MEMO FOR: Hugh L. Thompson, Jr. Director
Office of Nuclear Material Safety and Safeguards (Return to WM, 623-SS)

FROM: Robert E. Browning, Director
Division of High-Level Waste Management
NMSS

SUBJECT: IODINE-129 GROUNDWATER DATA AT THE HANFORD, WASHINGTON SITE

ENCLOSURE 1

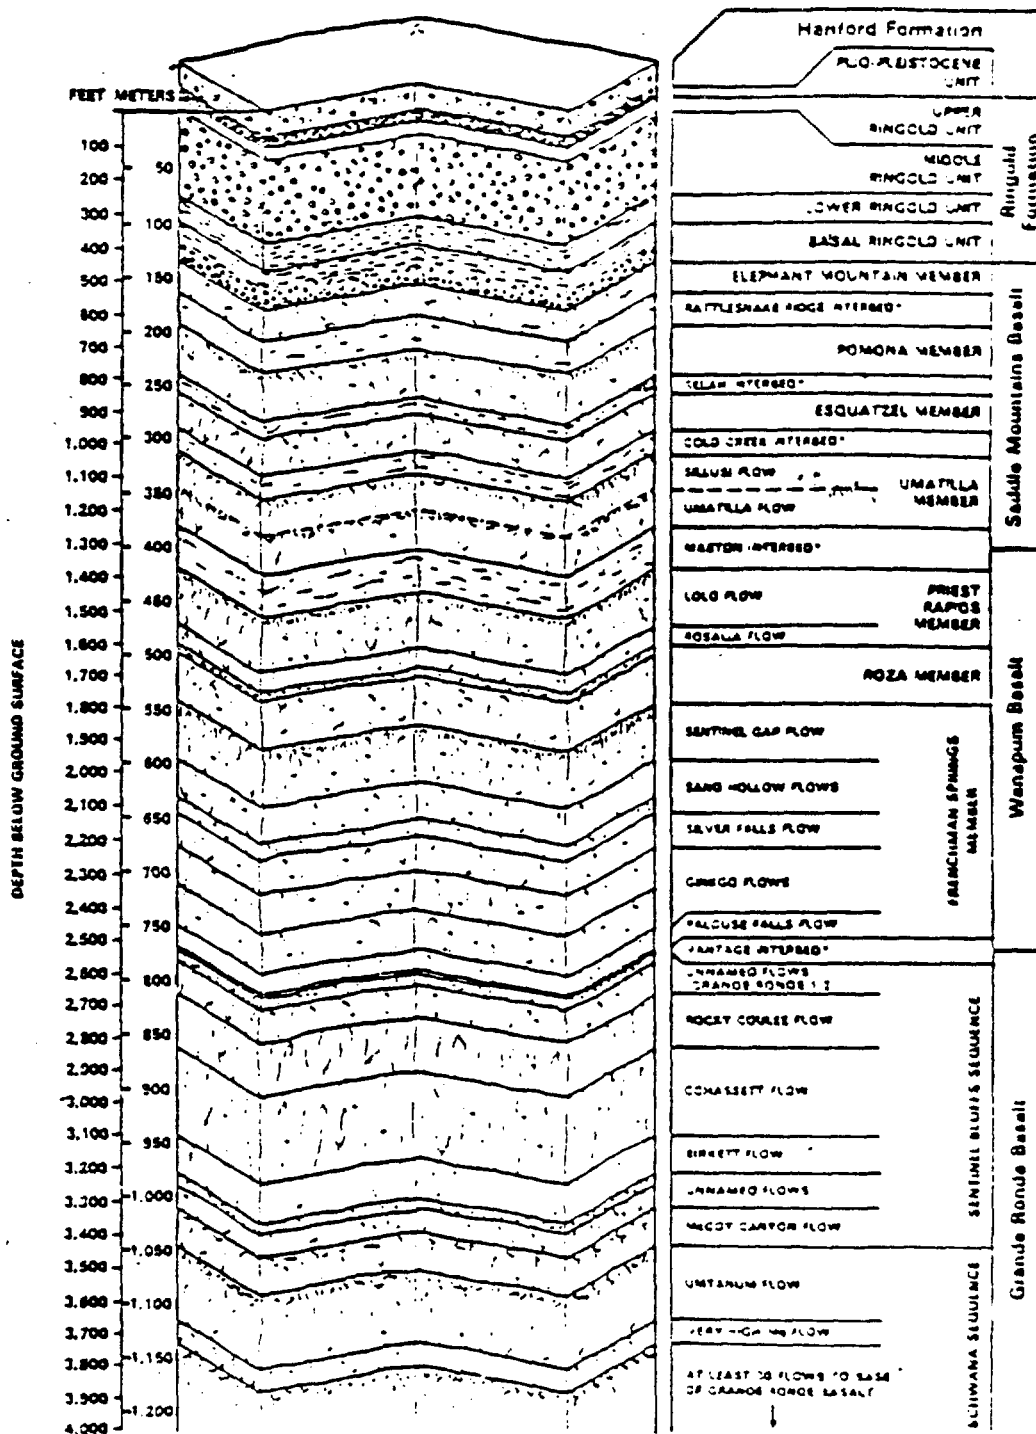
Based on our review of DOE's August, 1987 report, the NRC staff position continues to be that none of the historical Iodine-129 groundwater data identified to date indicates the site should be disqualified as a repository site. The historical Iodine-129 data collected is from aquifers at depths of about 2,000 feet or less. The repository is located at approximately 3,000 feet (Enclosure 1). These data are therefore not sufficient to resolve the issue of the potential for upward migration from the repository horizon to shallower aquifers. The data needed to support regulatory conclusions about the adequacy of the Hanford site will be obtained by DOE through testing near the proposed site and at the proposed depth of the repository. In an April, 1987 meeting at the Hanford site the NRC staff agreed with DOE's approach for this testing. The historical groundwater monitoring data will be considered by the NRC staff along with data from the program of deep groundwater testing as part of the DOE site characterization effort.
